Vancouver Building By-Law 2025 – August 2024 Public Review of Proposed Changes

Proposed change to Sprinkler Design

Code change number: 24-0001

Figure A-3.3.7.7.(3) & (4)

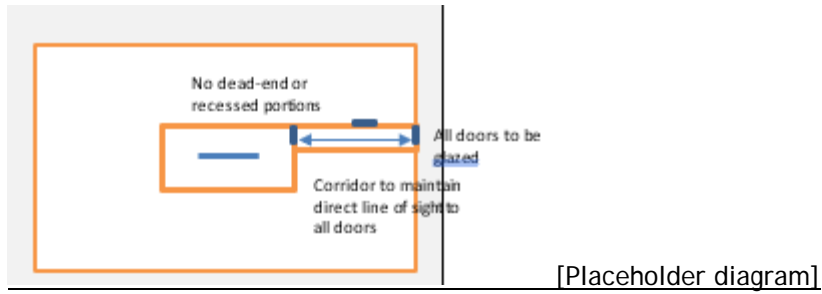
The proposed change are revision to the Storage Garage security provisions that will permit the interconnection of storage garage stairs exit, with egress from the ground floor areas. This is reflective of changing building design priorities and challenges.

Clause (4)(b) is intended to provide a relaxation for mixed use buildings where reasonable security features have been implemented to ensure that occupant are not subject to an unacceptable risk of physical assault. Occupants using the exit are made aware of conditions in the exit due to increased visibility through glazed doors and clear sightlines, and can remain in a place of safety until they exit. Ancillary doors providing access to the exit serving the storage garage are to be provided with security measures to prevent general use of the exit by unauthorized persons, except for emergency egress.

Figure 1: Operable Window Effective Opening Area

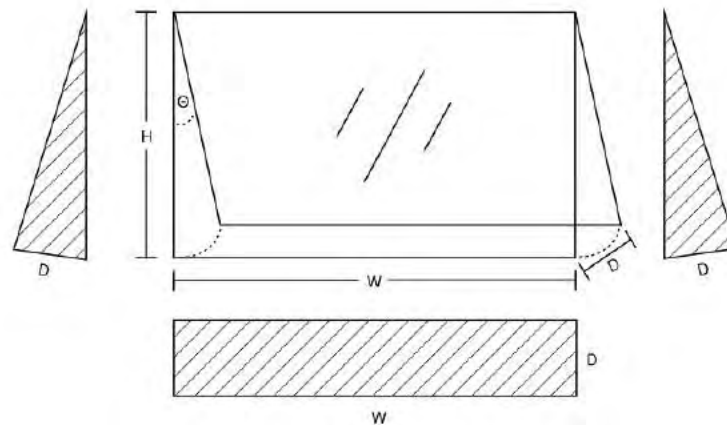
When modelling natural ventilation for passive cooling, the effective operable window area must be calculated based on the dimensions of the opening, insect screens, opening operation type, and any limitations to degree of opening, such as window limiters. For example, effective operable area of a top hung window is calculated as the hatched areas in Figure 1. Effective operable area can not exceed 100% of the operable window area. Insect screens are to be accounted for in the effective operable area. Unless otherwise known, insect screens are assumed to be present for all operable windows and have a free-area of 70%, reducing the effective operable area by 30%.

~~2) Access routes shall be provided to a *building* so that~~

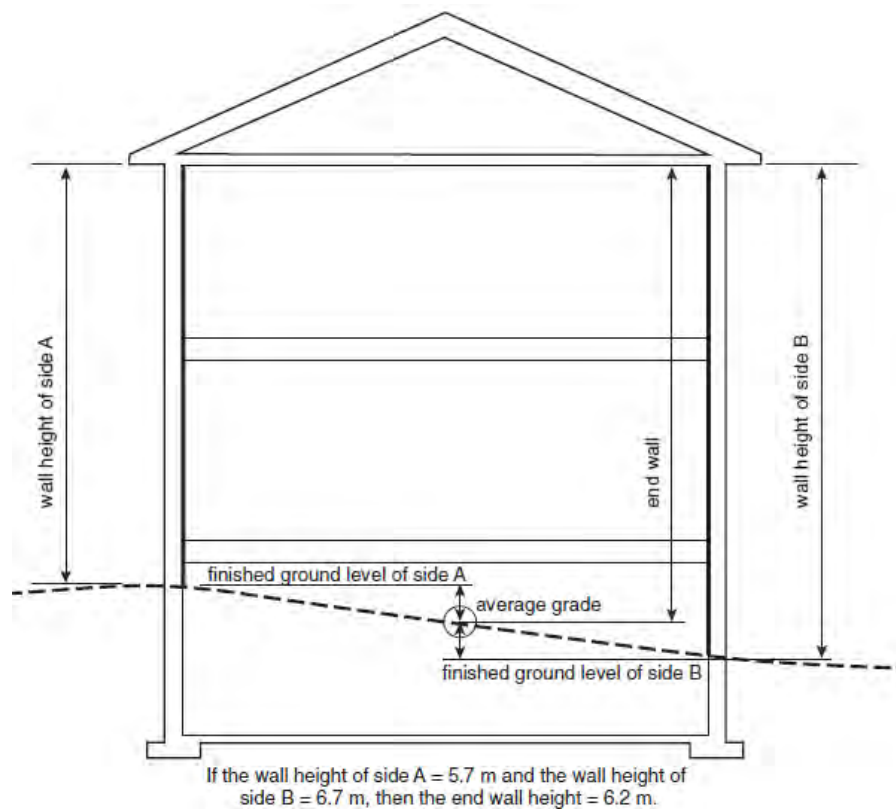
5) Where the access route runs continuously across the face of a *building*, the length of the access route shall be measured by measuring the shortest distance between a line drawn perpendicular to the access route and through the hydrant and a line drawn perpendicular to the access route and through the principal entrance of the *building*. (See Note A-3.2.5.5.(5).)

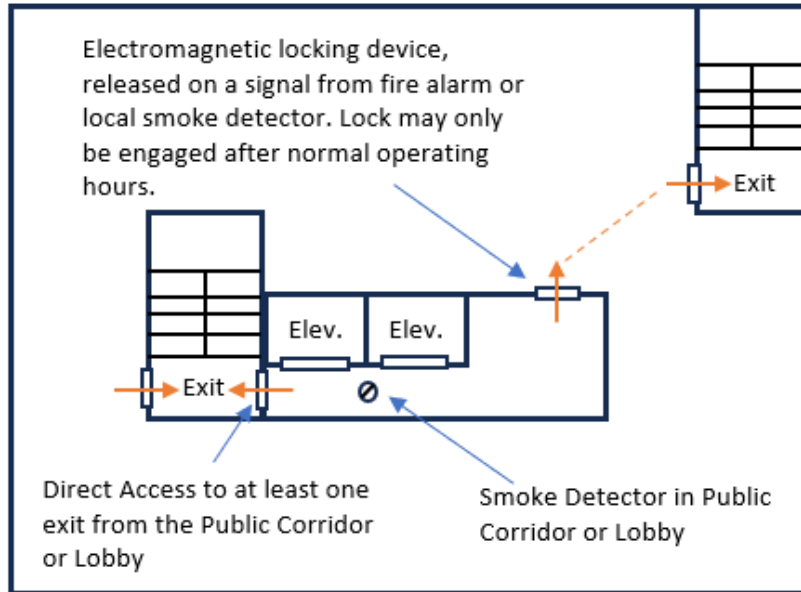
It is a common alternative solution request to provide electromagnetic locking in public corridors and lobbies to secure the main entry of larger suites during hours where occupants are not expected (not just after business hours as staff may still be present), where the suite entry door provide a means of egress to reach an exit located within the suite. This would reduce access to a single exit from the public corridor or lobby. Alternative solution to address this condition are usually varied, add complexity or delay to otherwise simple building permits.
